APPENDIX G INDEPENDENT TRAFFIC ASSESSMENT

To	Amy Watson / Ben Lusher	From	Gillian Austin
Copy		Reference	234109
Date	26 February 2014	Pages (including this page)	7
Subject	Rozelle Village – Review of GTA Response dated 25th February 2014

**Project: Rozelle Village Revised
Scheme
Traffic & Transport Review**

Figure 4.2 Inconsistent road category coding

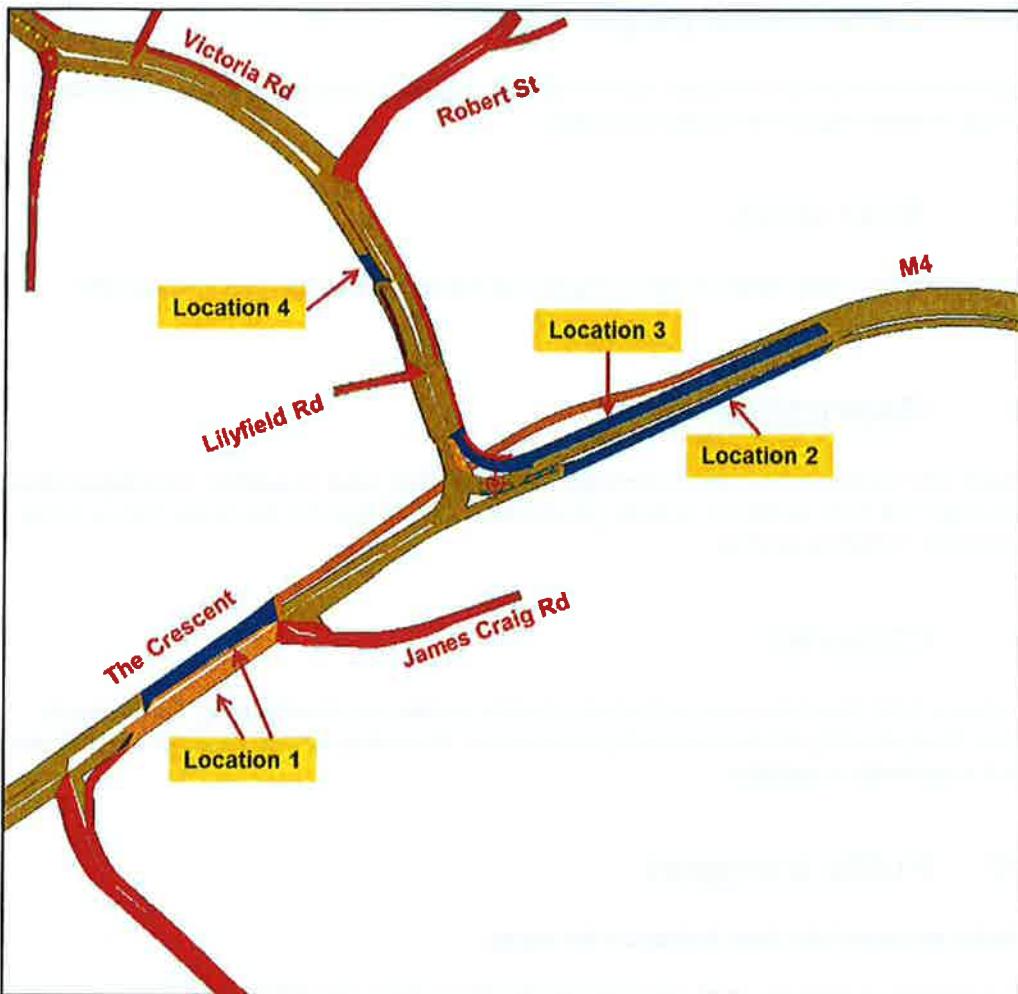
Inconsistent category link coding was observed in a number of locations in the base models as shown in Figure 4.2:

- **Location 1:** The Crescent (in both directions) between Victoria Road and City West Link was coded as inconsistent categories (category 32 and 33 vs 49, 50, 56 and 61) with different category speeds
- **Location 2:** M4 Western Distributor Freeway between ANZAC Bridge and The Crescent was coded as inconsistent categories (category 32 vs 49 and 75)
- **Location 3:** Victoria Road (eastbound) between Lilyfield Road and ANZAC Bridge was coded as inconsistent categories (category 77 vs 50 and 55)
- **Location 4:** Victoria Road (northbound) between Lilyfield Road and Robert Street was coded as inconsistent categories (category 76 vs 50).

Recommendation: Links should be coded with consistent categories along similar lengths of road. Category cost factors should be consistent for roads at the same level in the road network hierarchy; link cost factors should be used for route cost calibration.

Figure 4.3 Signal coding error

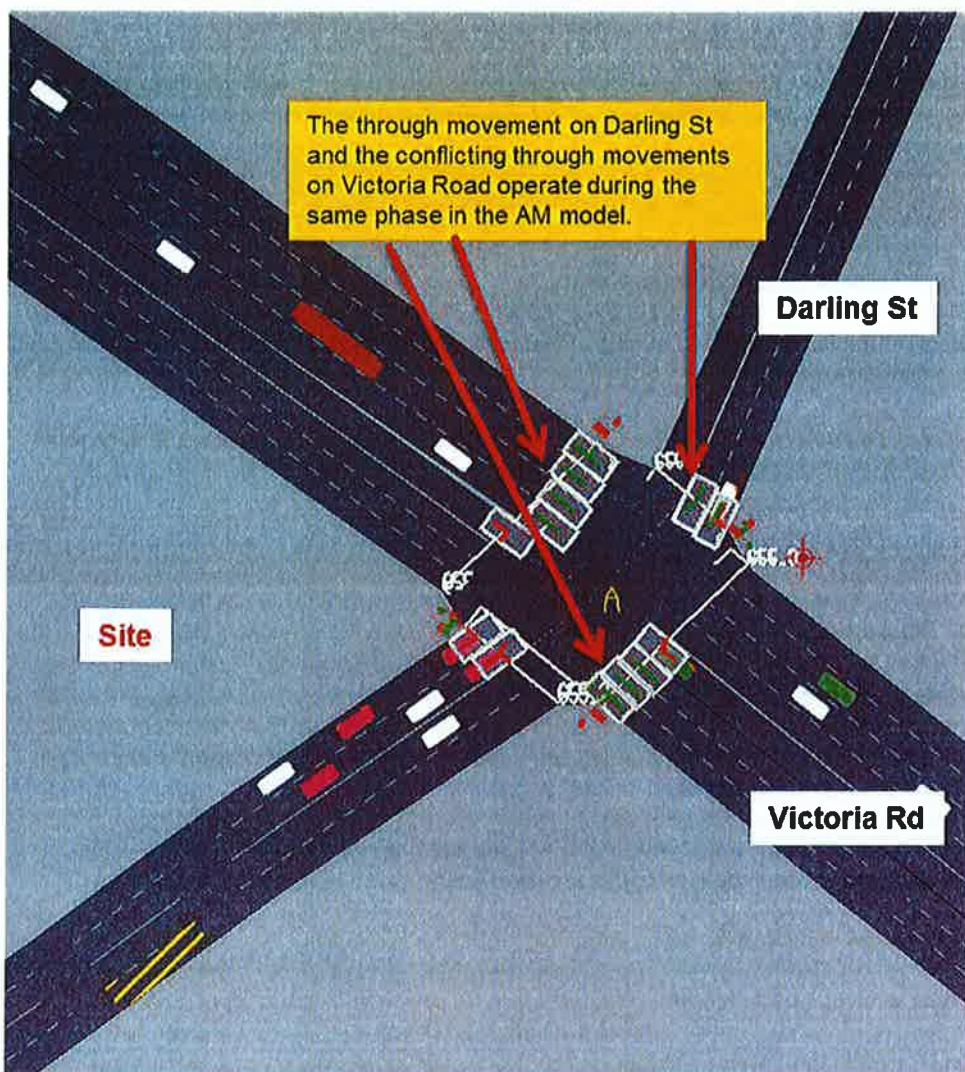
A review of signal operations in the model reveals the following error as shown in Figure 4.3:

- The through movement on Darling Street run simultaneously with the conflicting through movements (in both directions) on Victoria Road in the AM base model.

This coding error is likely to have significant impact on the performance of the Victoria Road/Darling Street in the vicinity of the site.

Recommendation: Review the coding of signal operations in the AM model and make adjustments where necessary. Update base model calibration appropriately

Figure 6.1 Signal timings at Victoria Road/Wellington Street, Base and Proposed

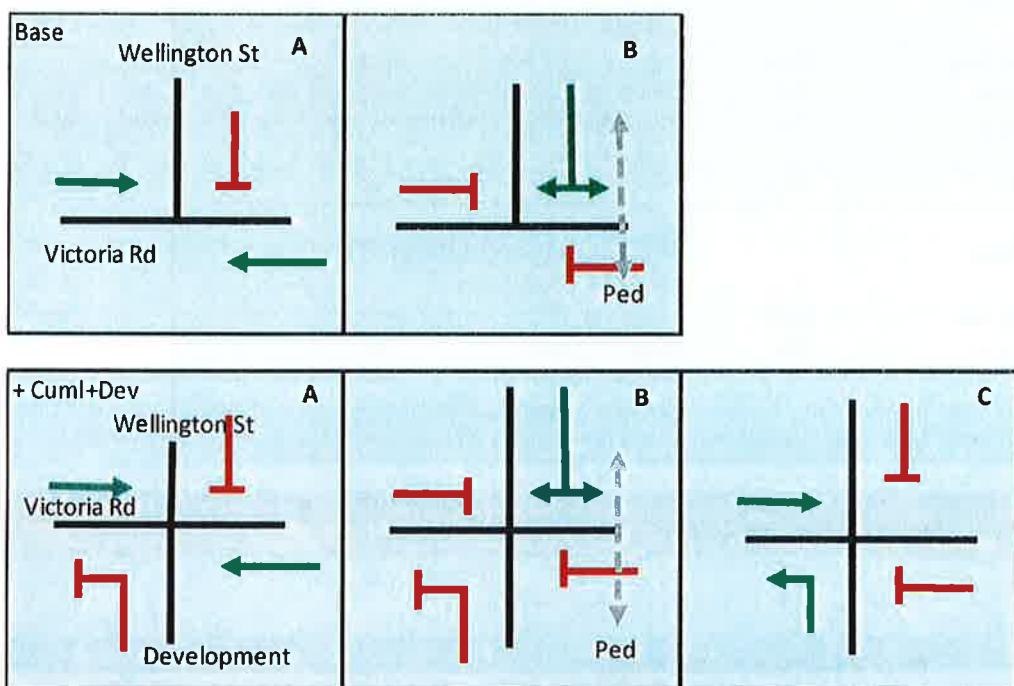
In order to accommodate the development access, a fourth leg has been added to the Wellington Street/Victoria Road Intersection. An addition 'Phase' has been added to the traffic signals to allow traffic to egress the site (left only). Figure 6.1 shows the Base case signals phasing and the revised phasing with the Rozelle Village Development in place.

Table 6.2 shows the green time allocation for the base case modelling and with the development in place. The table highlights that green time for Wellington Street is reduced in all three peaks when the fourth leg is introduced. The Westbound movement on Victoria Road also reduced in all three scenarios.

Figure 6.2 Signal timings at Victoria Road/Wellington Street

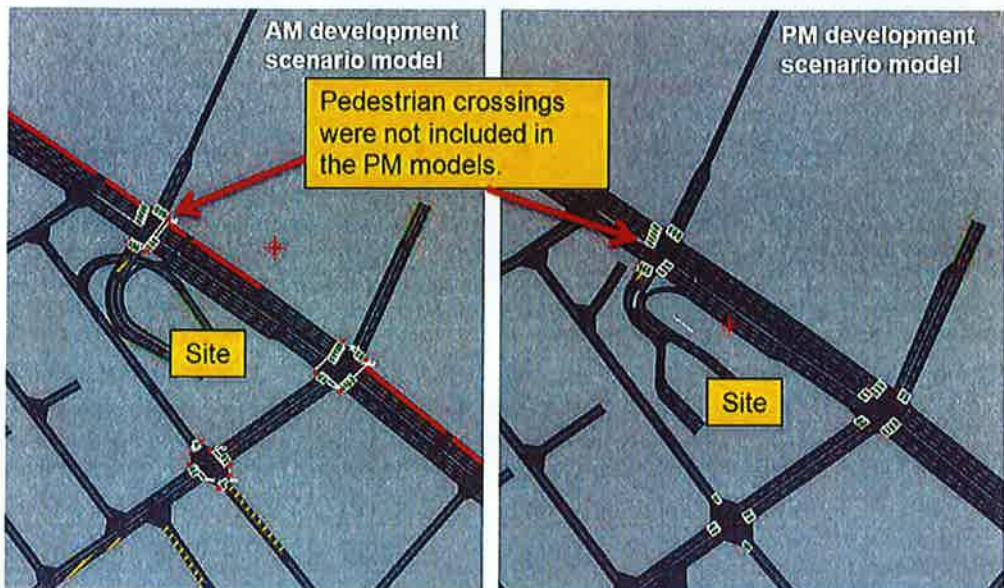
A pedestrian crossing has been included in the AM peak and Saturday peak models but not in the PM peak model. No justification is provided as to why a pedestrian phase has not been included during the PM peak.

Recommendation: Include a Pedestrian Crossing in the PM Models.

Figure 6.3 Coding error at Robert Street

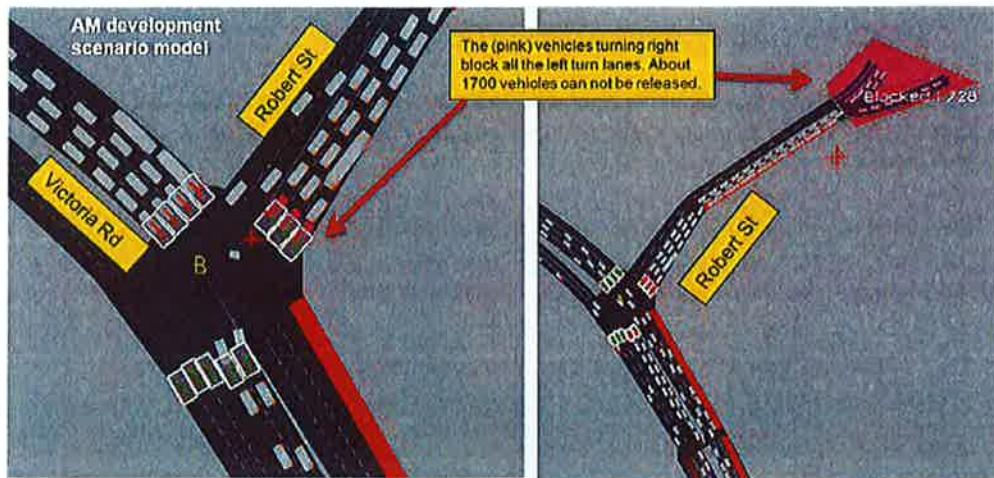
In the AM peak model (with the Rozelle Village development in place), nine trips have been assigned from Robert Street (Zone 13) to the Rozelle Village development. During the AM peak the right turn from Robert Street into Victoria Road is banned. Because the banned turn is defined at a signalised intersection, the nine trips are released onto the network. These trips are subsequently unable to turn right at the intersection of Robert Street/Victoria Street eventually blocking all traffic from exiting Robert Street (this generally occurs about 30 minutes into first peak hour). With no traffic able to exit Robert Street, there are over 1,700 unreleased vehicles by the end of the second peak hour.

The results of the AM peak modelling are severely impacted by this issue. The results presented in the GTA report show that the 'Base +Cumulative+ Rozelle Village Scenario' actually improves network operations when compared against the AM base case scenario. Table 4.5 in the GTA PPR shows the LOS at Robert Street/Victoria Street goes from LOS F in the Base to LOD D with the development in place. This is because so much so much traffic is unreleased onto the network and Victoria Road operates much better as a result.

Recommendation: This issue need to be fixed and the AM peak models rerun. All AM peak reporting (with the development in place) will need to be undertaken again.

Figure 2.1 Paramics snapshot showing impact of coding error

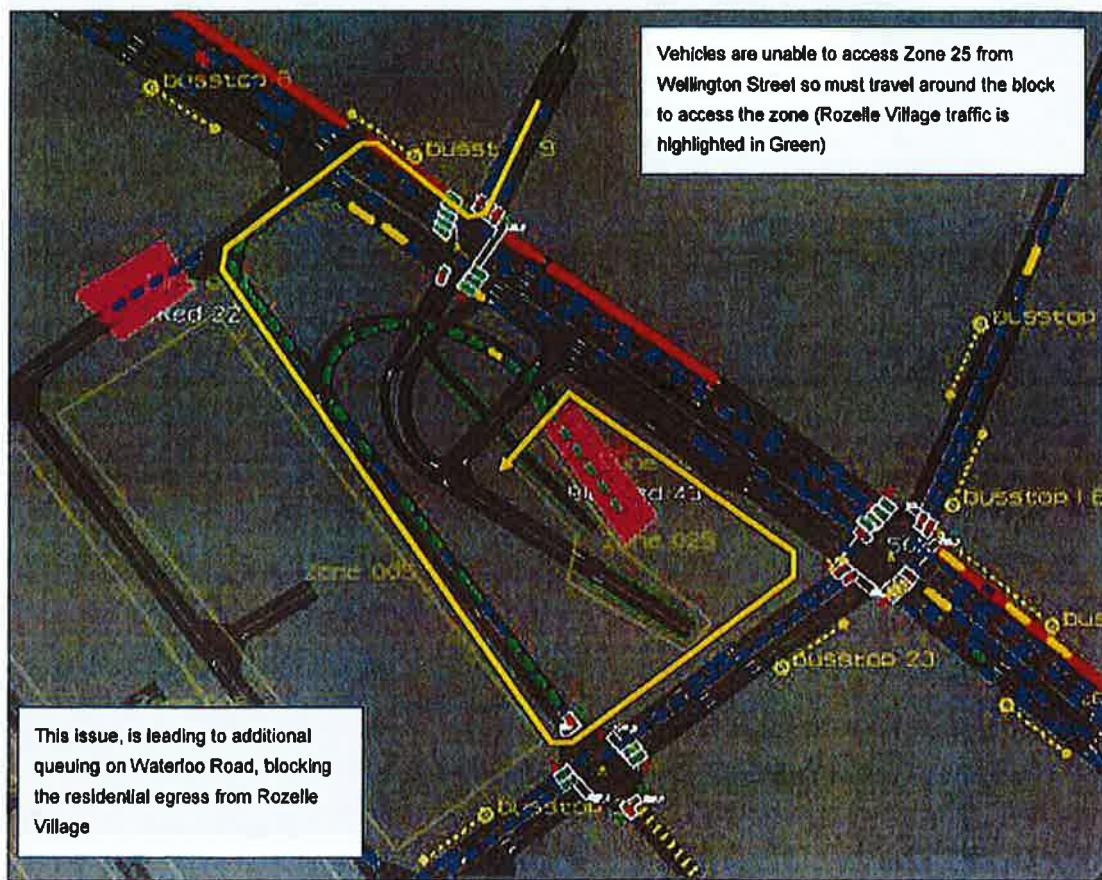
The issue identified relates to Zone 25 (the zone associated with retail component of the Rozelle Village development). Zone 25 has two links feeding it, the left turn from Victoria Road and the straight through movement from Wellington Street. The issue identified is related to the second link, the ingress from Wellington Street. Zone 25 does not cover half of the link (Node 60 to Node 58), which means that no traffic can access the zone from this link. As a result all trips which should access the site from Wellington Street need to find an alternative route to access the site. In this instance, the affected vehicles are turning right from Wellington Street into Victoria Road, left into Moodie Street, and then traveling around the block to use the alternative entrance from Victoria Road.

This issue leads to significant queuing on Waterloo Street blocking the egress from the Rozelle Village residential car park, resulting in vehicles being blocked in the residential car park for over an hour. Figure 2.1 shows a snapshot taken from the AM Peak model, highlighting the issue described above.

As a result of this issue the results and findings related to the AM peak modelling are not valid. It is recommended that this issue is fixed and the models rerun.

Figure 3.1 Paramics snapshot showing queuing on Darling Street

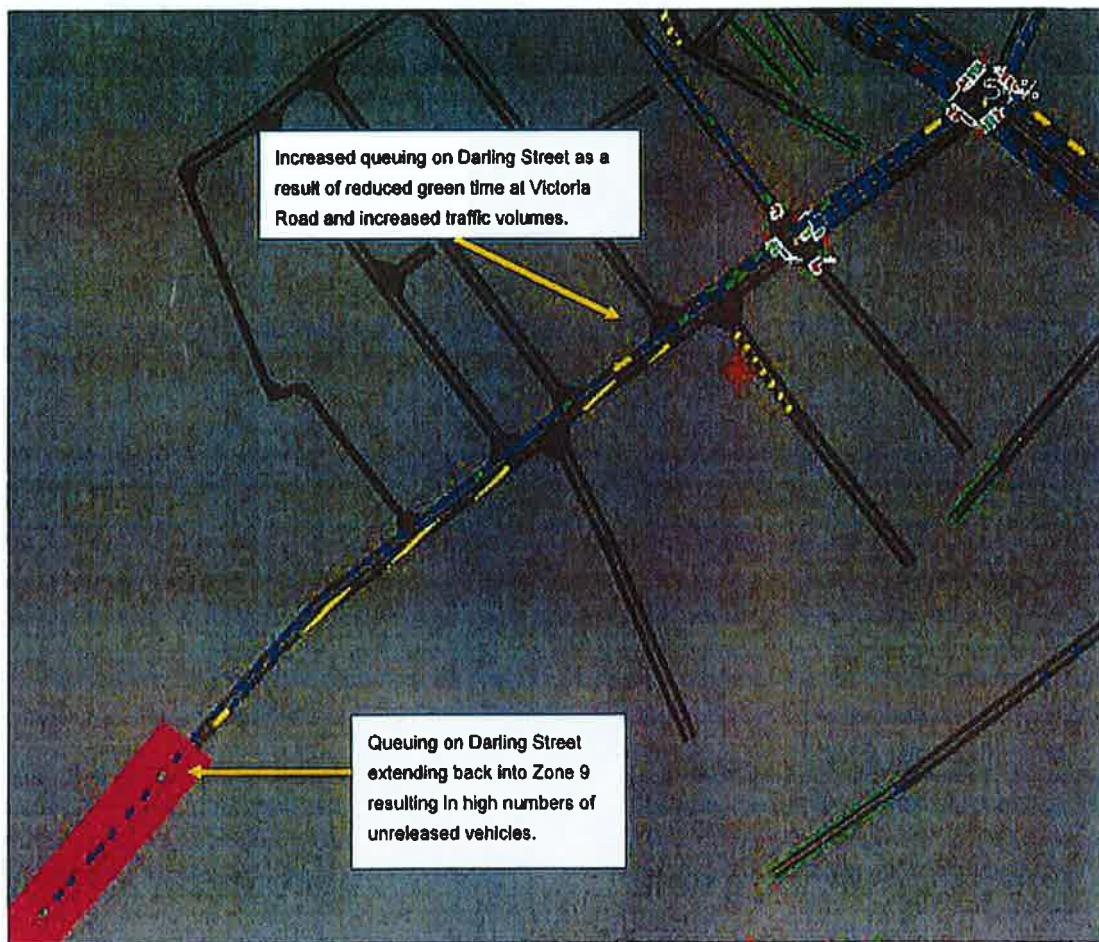
A review of the PM peak with Rozelle Village models shows that traffic signal timings at the intersection of Darling Street and Victoria Road have been changed from the Base Case and Base + Cumulative models. These changes result in reduced green time for Darling Street (travelling north) of 4 seconds per cycle. This reduction in green time combined with the increased development traffic, is exacerbating congestion and delays on Darling Street during the PM peak. As a result, queuing extends back into the zone (Zone 9) during the PM peak. At the end of the peak period 56 vehicles (from Appendix C) are blocked within Zone 9 (note that no vehicles are blocked in the Base + Cumulative Model). The additional delays on Darling Street are also reflected in the bus travel times (see section 3.4). The Figure 3.1 highlights the congestion on Darling Street.

Figure 3.2 Lane choice issue on City West link approach to Victoria Road

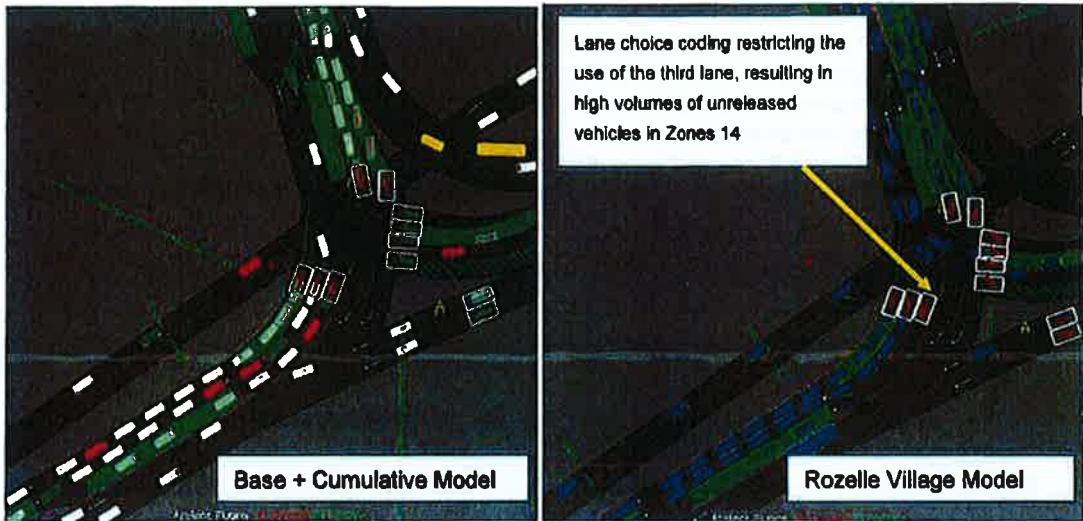
Upon further investigation, the difference in unreleased vehicles can be attributed to different lane choice configurations applied in each of the models. In the Rozelle Village model, the City West Link and Anzac Bridge approaches to Victoria Road are only utilising two of the three lanes available while all three lanes are being utilised in the Base + Cumulative Model. As a result the capacity of these approaches is reduced significantly resulting in extensive queuing on Anzac Bridge and the City West Link. Furthermore, this means that there are approximately 1,600 vehicles less travelling outbound on Victoria Road during the PM peak in the Rozelle Village model compared with the Base + Cumulative model. Figures 3.2 and 3.3 highlight this issue.

This issue needs to be rectified to understand the true impacts during the PM peak.

Figure 3.4 Paramics Snapshot showing internal queuing issues

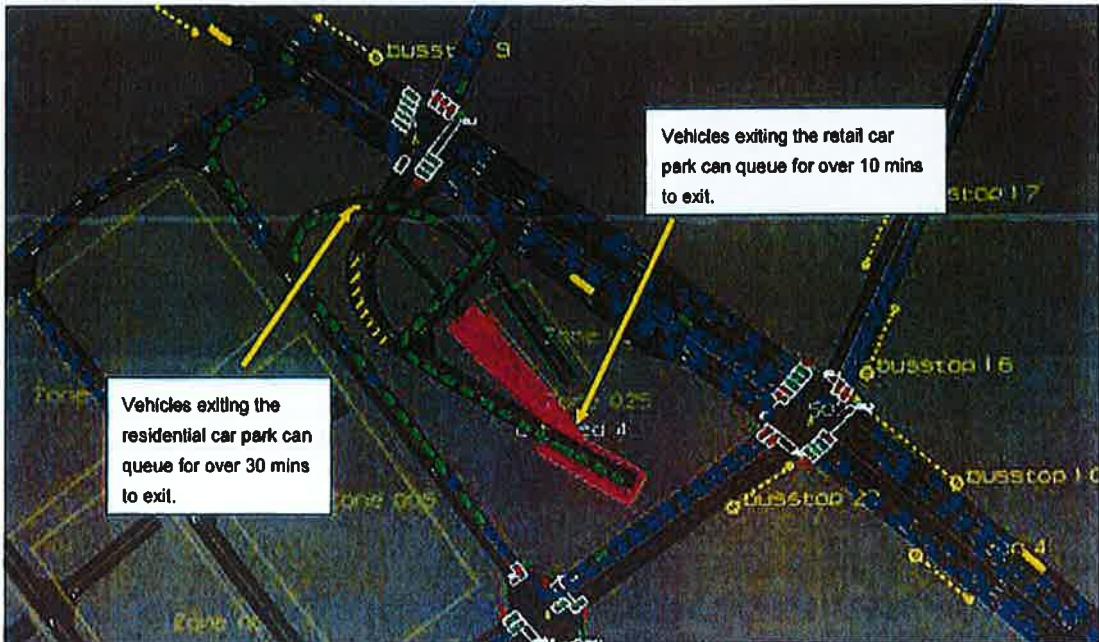
The PM peak modelling shows that significant queuing occurs within the development. Both the Retail and Residential car park are affected. Queuing from the Retail car park extends back into the zone, a distance of approximately 130 m. This would result in queuing beyond the internal boom gates. A review of the modelling indicates that vehicles seeking to leave the retail car park can queue for over 10 minutes to exit the car park.

Due to congestion on Waterloo Road, vehicles have limited opportunities to exit the residential car park during the PM peak. This leads to significant queuing within the car park. A review of the modelling indicated that vehicles seeking to leave the residential car park can queue for over 30 minutes to exit the car park. Figure 3.2 shows a snapshot taken from the PM peak model, highlighting the queuing described above.
